Report Type: DA Access Report
Reference Number: 19023
Client: Alpha Engineering & Development P/L
Site Address: 159 Jamison Road, Penrith, NSW

ACCESS REPORT

This Access Compliance Report is to accompany a Development Application for the Boarding House development proposed at 159 Jamison Road, Penrith, NSW.

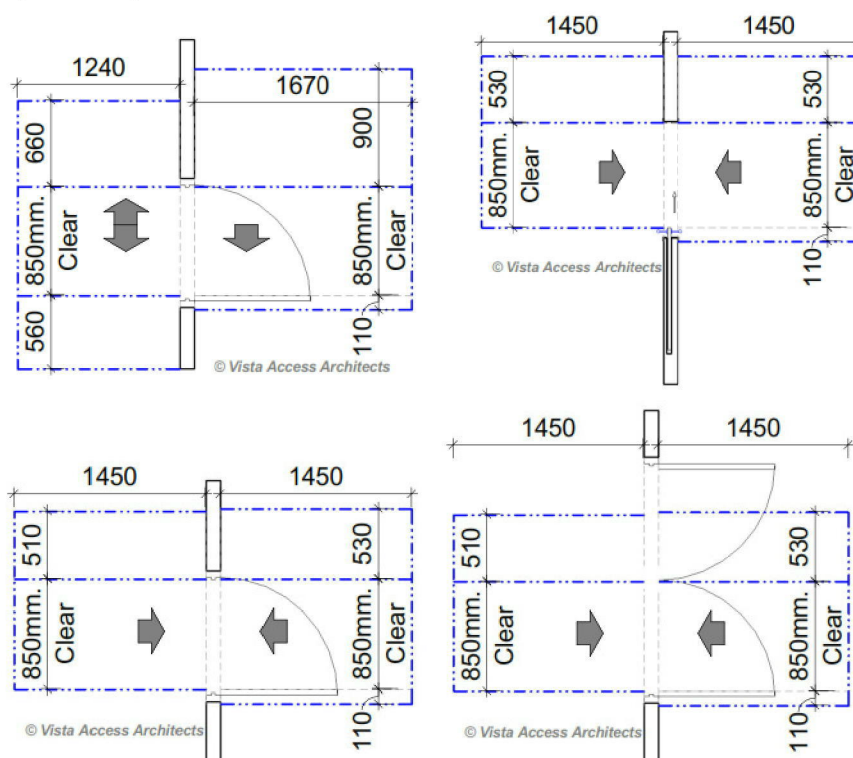
The development has a requirement for 2 Accessible SOUs.
The nominated Accessible SOUs are Unit numbers, 1.01 and 1.02 as shown below.

Requirements as per AS1428	R	C	Comments
1	Doorways			
	All doors including entry door to provide 850mm clear opening space with the necessary door circulation spaces and fixtures as specified under AS1428.1	☑	☑	Complies Details to be verified at the CC stage of works.
2	Bathroom			
	At least 1 Bathroom to accommodate, WC pan, Shower and handwash basin with the necessary fixtures and circulation spaces as specified under AS1428.1	☑	☑	Complies Details to be verified at the CC stage of works.
3	Laundry			
	Where internal laundry provided, provide for a space of 1550mm space in front of laundry appliances.	☑	☑	Complies Details to be verified at the CC stage of works.
4	Main bedroom			
	At least 1 bedroom to have a queen bed with circulation space of 1540mm x 2070mm at the base or side of the bed and at least 1M on the other 2 sides. In the case of a boarding house a single bed may be used with the same circulation spaces.	☑	☑	Complies Details to be verified at the CC stage of works.

5	Living areas			
	Adequate circulation space is to be available after the placement of furniture. Circulation space of minimum 2250mm diameter is considered to be appropriate.	<input checked="" type="checkbox"/>	<input checked="" type="checkbox"/>	Complies Communal room has been provided which is designed to be accessible. Details to be verified at the CC stage of works.
6	Kitchen / Kitchenette			
	Where internal kitchenette provided, 1550mm clear spaces is required in front of the benchtops. Provide long arm lever tap and 1 double GPO within 300mm of front bench. Consideration to be given to provision of an 850mm section without base cabinetry or removable cabinetry to allow for access to benchtop and a benchtop space of 800mm between the fridge and cooktop.	<input checked="" type="checkbox"/>	<input checked="" type="checkbox"/>	Capable of compliance. Details to be verified at the CC stage of works.

7	Balconies and outdoor areas			
	Where access is available from the unit to the outdoor areas such as balconies and courtyards, an accessible threshold is required, with door tracks for sliding doors (if any) to be flush with the internal floor level and max height of external threshold ramp of 35mm height.	<input checked="" type="checkbox"/>	<input checked="" type="checkbox"/>	Capable of compliance. Details to be verified at the CC stage of works.
8	Flooring			
	All flooring is required to be step free. Construction tolerances, slip resistant and waterproofing to be as required under relevant Australian Standards.	<input checked="" type="checkbox"/>	<input checked="" type="checkbox"/>	Capable of compliance. Details to be verified at the CC stage of works.
9	Switches and GPOs			
	All switches, GPOs and controls (including controls for intercom facilities) to be accessible as required under AS1428.1	<input checked="" type="checkbox"/>	<input checked="" type="checkbox"/>	Capable of compliance. Details to be verified at the CC stage of works.

BCA Part D3.5 Accessible Carparking

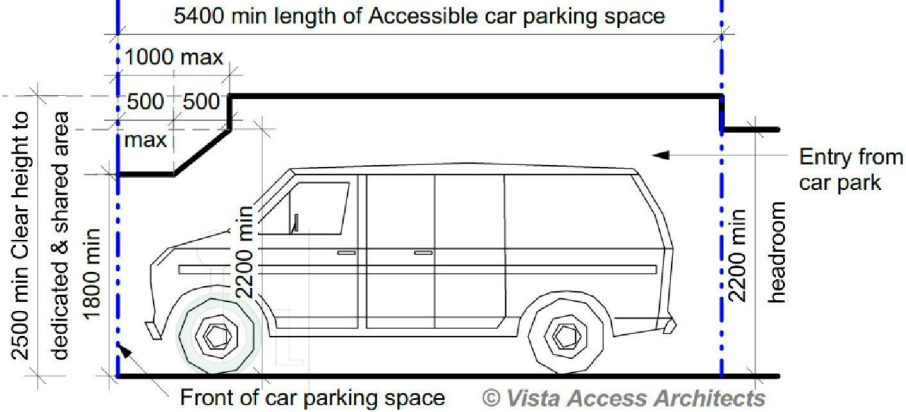
Compliance Comments	<p>Complies. Total number of carparking spaces provided = 10 Total number of accessible parking spaces provided = 2 Detailed features of the accessible parking space to be verified at CC stage of works.</p>
----------------------------	---
